IN THE MATTER of a resource consent application to subdivide

STATEMENT OF EVIDENCE OF PAIGE PAMELA FARLEY

ON BEHALF OF BERGGREN TRUSTEE CO. C/- MARIA BERGGREN

(Civil Engineering)

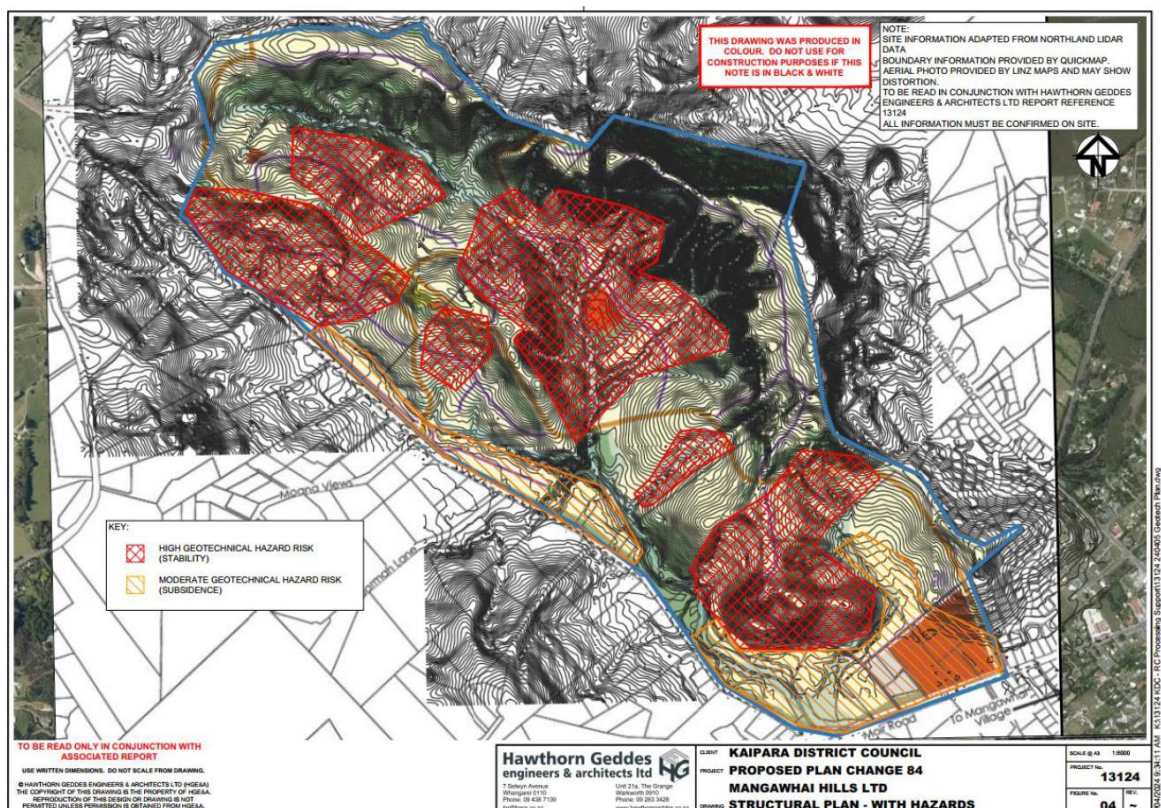
18. Given the topography constraints and the geotechnical hazard risk identified by Hawthorne Geddes (refer to the image below) there is limited space available for a stormwater attenuation pond to be sited. In particular, in the southern catchment that is owned by multiple landowners. Further guidance and direction should be provided by Chester within the SMP and appropriate sites for stormwater ponds should be identified and then shown on the Structure plan, with corresponding Development area provisions to secure the construction and vesting of the ponds.

28. Whilst geotechnical engineering is outside of my expertise, it is noted that the primary north south road access proposed from Moir Street (referred to as “Primary Road 2” in the latest structure plan) is shown to fall within an area of high geotechnical hazard risk (stability) as identified by Hawthorne Geddes in the image above and will have an effect on viable access options within the PPC. Similarly, the secondary access proposed to terminate within our client’s land is also indicated to lie within an area of high geotechnical hazard risk (stability). Certainty of the proposed access routes is required and should be obtained as part of the structure plan stage. Without this certainty large tracts of the Plan Change area may not be able to be provided with road access and will therefore not be able to be developed for urban development as planned. This matter is addressed in further detail in the Planning evidence of Ms O’Connor.
